SOUTHERN ENVIRONMENTAL LAW CENTER

RE: Concerns Regarding the U.S. Department of Energy's Recent Actions During the U.S. Environmental Protection Agency's Review of the December 31, 2020 Radionuclide Pollution Decision for the Oak Ridge Reservation Facility in Oak Ridge, Tennessee

Figure 1. Site Characterization: Groundwater Levels.[17]

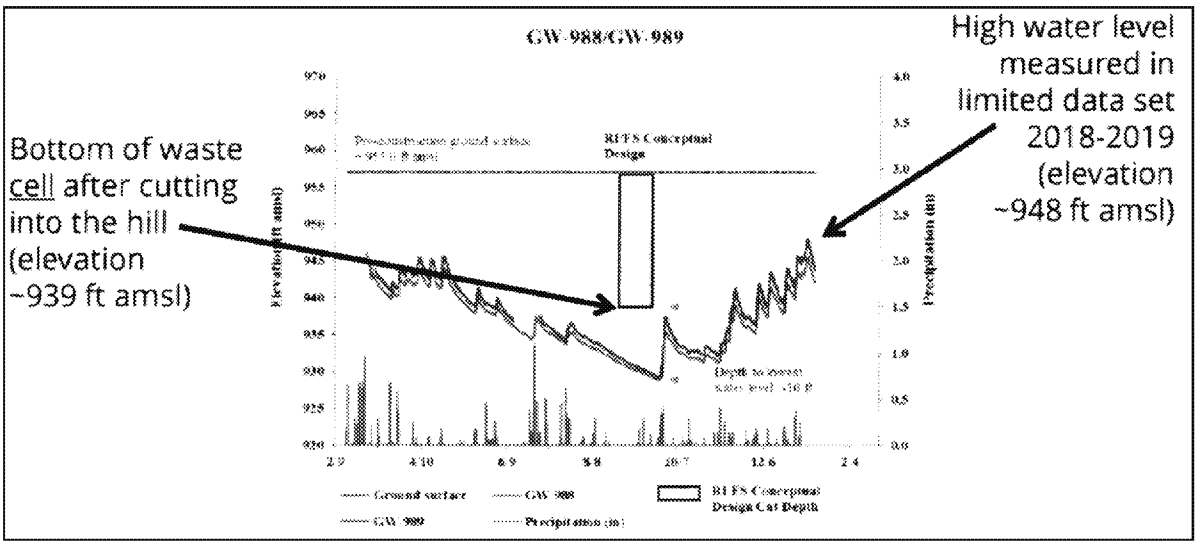
New groundwater information significantly changes the features of the remedy the Department has proposed: to construct a landfill that would taint a greenfield on the Oak Ridge Reservation (the Proposed Plan).[11] In the Proposed Plan, the Department claimed the location was the "most appropriate area on the [Oak Ridge Reservation] for locating an onsite disposal facility" in part due to its "groundwater flow conditions," citing the "considerable amount of information" available about the subsurface and groundwater conditions in Bear Creek Valley.[12] At the time of the public comment period, the Department told the public that the landfill would maintain a "10 ft geologic buffer above seasonal high groundwater."[13] The Department said that "[r]esults of the Phase 1 site characterization confirm the acceptability of the [landfill] site for a new, low-level waste landfill and support final site selection."[14] However, recently released Technical Memorandum 2 reveals that groundwater levels at the site are significantly higher than originally anticipated and understood.[15] According to the new groundwater information, a substantial portion of the landfill would sit below the water table.[16] (Figure 1).

The newly revealed groundwater levels at Bear Creek Valley raise critical questions about the design and performance of the landfill as proposed. The U.S. Environmental Protection Agency's (EPA) comments on Technical Memorandum 2 underline that the proposed landfill must have "a completely unsaturated clay geobuffer layer to demonstrate the protectiveness requirements necessary to obtain waivers."[18] However, the landfill as proposed would sit below the water table, and there is a substantial risk that waste would not be adequately contained.[19] The Tennessee Department of Environment (TDEC) stated that Technical Memorandum 2 "raises significant questions about how [the Department] will support the contention that the [proposed landfill] site is acceptable."[20] More explicitly, TDEC stated that Technical Memorandum 2 "makes it difficult to determine if the landfill can be constructed and operated in a manner that will meet the two CERCLA threshold criteria."[21] In the wake of this new information, the Department has not altered the Proposed Plan or given the public an opportunity to comment on the issues raised by this new information.

The public did not expect that the Department would propose, for a second time, to place a landfill in a location that is entirely unsuitable for containing hazardous and radioactive waste.
